T11/10-252v2 FC-BB-6: ASFC changes for FC pseudowire

To: INCITS Technical Committee T11  
From: David L.Black, EMC Corporation  
Email: black\_david@emc.com

Date: June 9, 2010

Subject: FC-BB-6: ASFC for the FC pseudowire

Figure X – FC-BB\_PW error indication control frame format

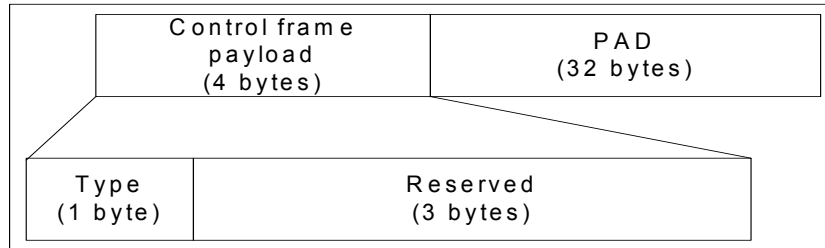
ASFC defines two control frames, ASFC\_PAUSE and ASFC\_RESUME (see Figure X and Table Y), that may be sent by one FC-BB\_PW device to a remote FC-BB\_PW device.

Figure X specifies the control frame formats for ASFC\_PAUSE and ASFC\_RESUME.

An FC-BB\_PW device sends ASFC\_PAUSE to a remote FC-BB\_PW device to direct that device to cease forwarding FC frames and FC Primitive Signals. Reception of a single ASFC\_PAUSE control frame suffices to trigger such cessation, which shall take effect:

- a) within 1 millisecond of reception of the ASFC\_PAUSE control frame; or
- b) immediately upon completion of the forwarding of an FC frame or FC Primitive Signal if forwarding of a frame or Primitive Signal is in progress when the ASFC\_PAUSE control frame is received and the time required for such completion is greater than 1 millisecond.

**Editor's Note:** FC-BB\_PW devices have considerably more functionality and buffering than FC-BB\_GFPT devices, hence the 25 microsecond reaction time value for GFPT was changed to 1 millisecond. Case b) is unlikely in practice, but is included for completeness.

**Figure 23 – FC-BB\_PW PING and PING\_ACK control frame format**

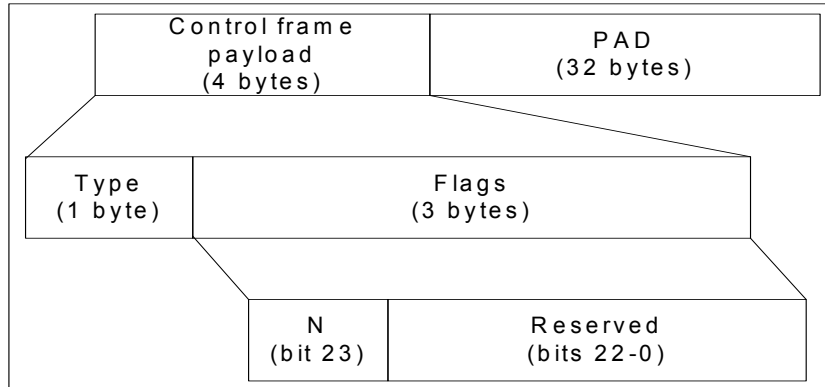
**Editor’s Note:** Renumber 6.4.7.3 and subsections to 6.4.7.4 and subsections, next change is in 6.4.7.4.3 (re-numbered from 6.4.7.3.3)

This standard specifies the use of Type field value 0x11 for transmission of error indications (see 6.4.8.2.2) [and specifies the use of Type field values 0x41 and 0x42 for ASFC\\_PAUSE and ASFC\\_RESUME \(see 6.4.7.3\).](#)

**Figure 24 – FC-BB\_PW error indication control frame format**

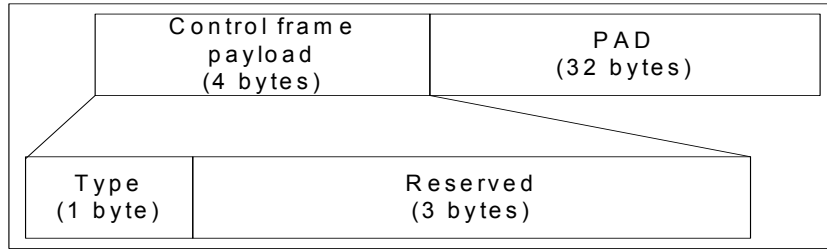
This standard specifies the use of Type field values 0x81 and 0x82 for transmission of FC-BB\_PW PING and PING\_ACK (see 6.4.7.4.3) [and specifies the use of Type field values 0x41 and 0x42 for ASFC\\_PAUSE and ASFC\\_RESUME \(see 6.4.7.3\).](#)
